February 3, 1978

INDIAN POINT NUCLEAR GENERATING UNIT NO. 1

AMENDMENT TO PROVISIONAL OPERATING LICENSE

Amendment No. 18  
License No. DPR-5

Figure 3.1 Facility Management and Technical Support Organization

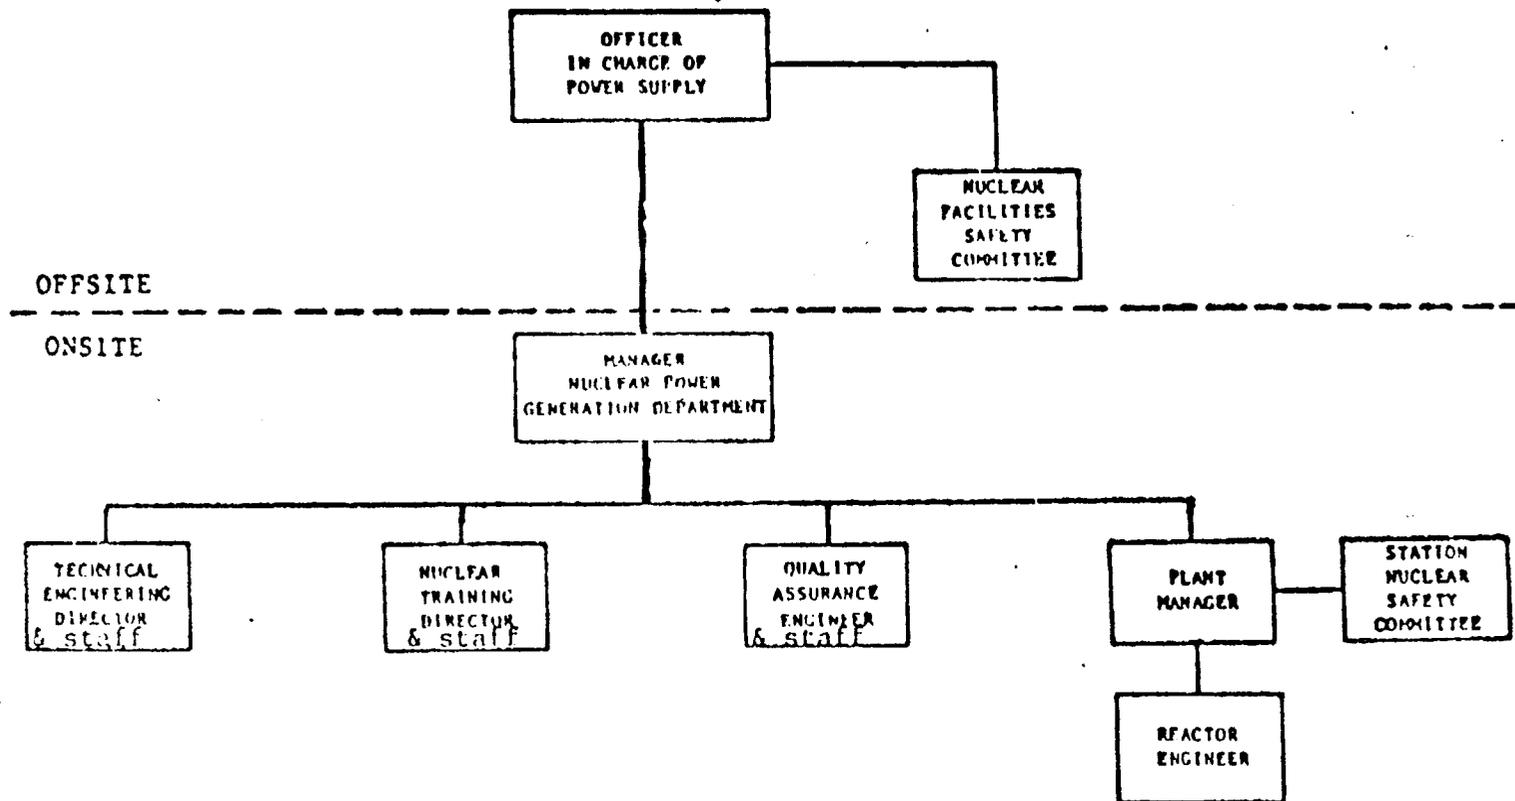
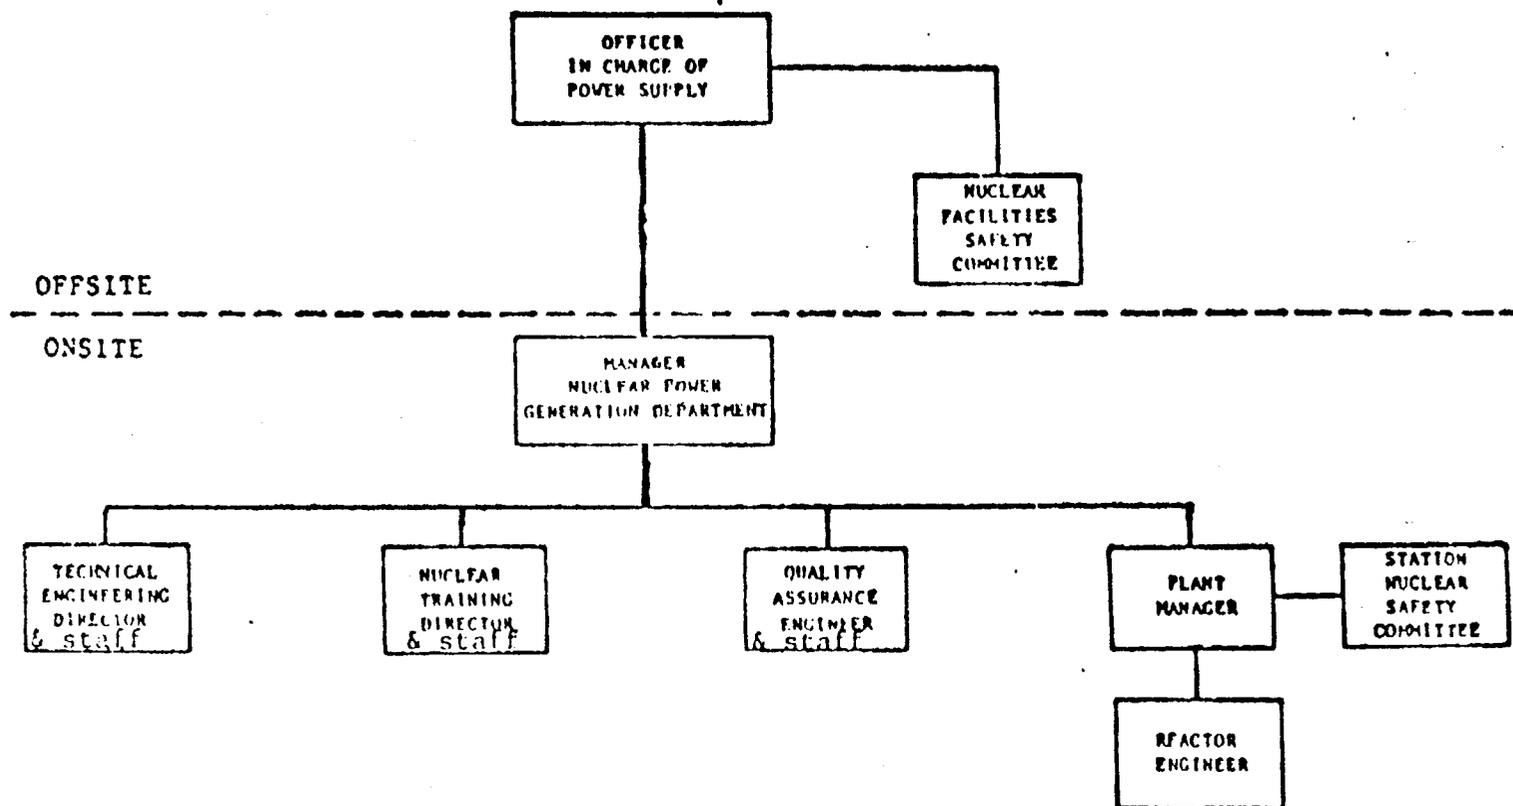
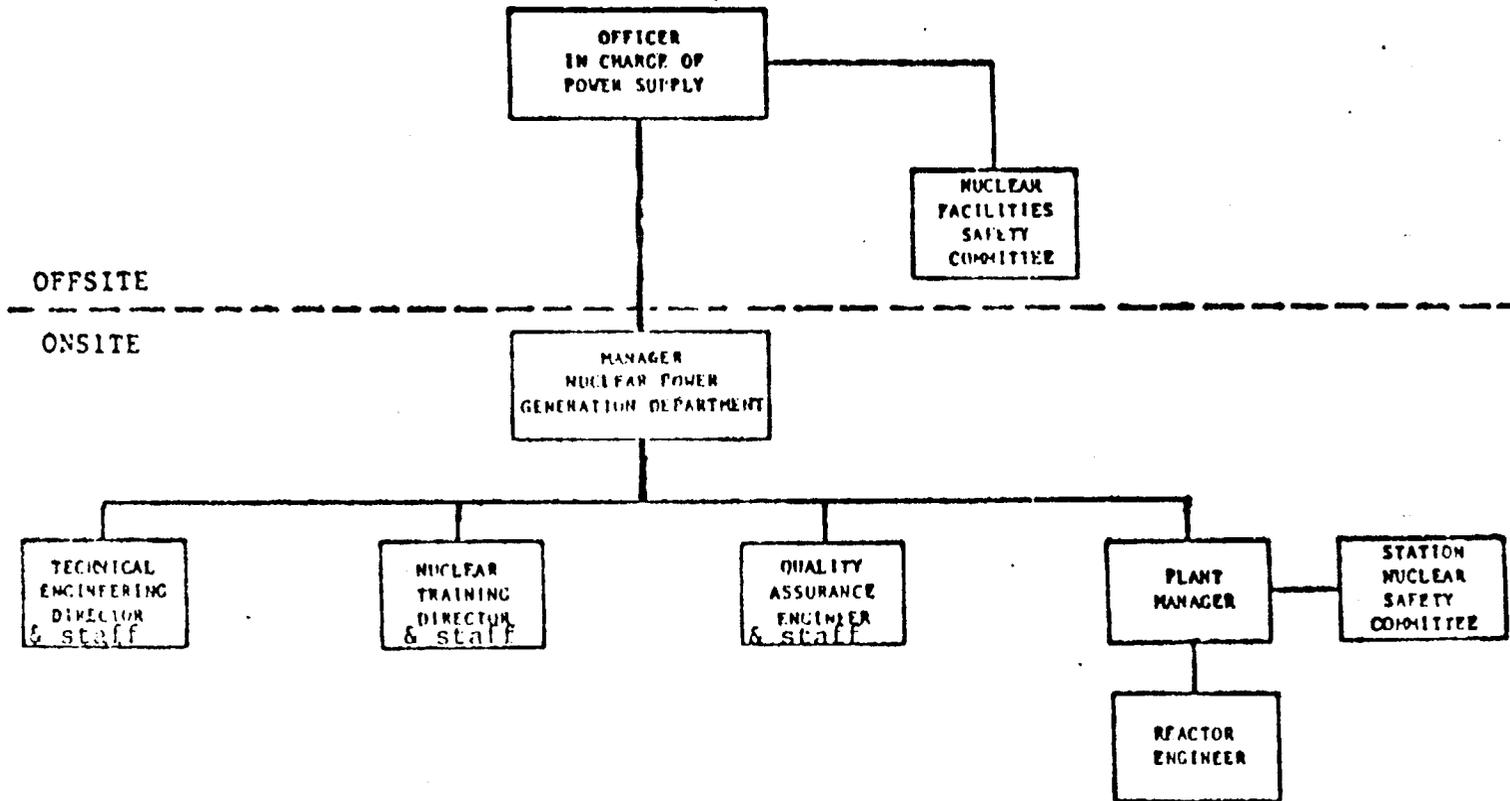
1. Change Technical Specifications to clarify Nuclear Facilities Safety Committee responsibilities;
2. Change organizational chart to reflect current organizational responsibilities to show that the Manager-Nuclear Power Generation Department would report directly to the Officer In Charge of Power Supply; and
3. For Units 2 and 3 add the Refueling Engineer as a member of the Station Nuclear Safety Committee.

3.1.1 The organization for facility management and technical support shall be as shown in Figure 3.1.
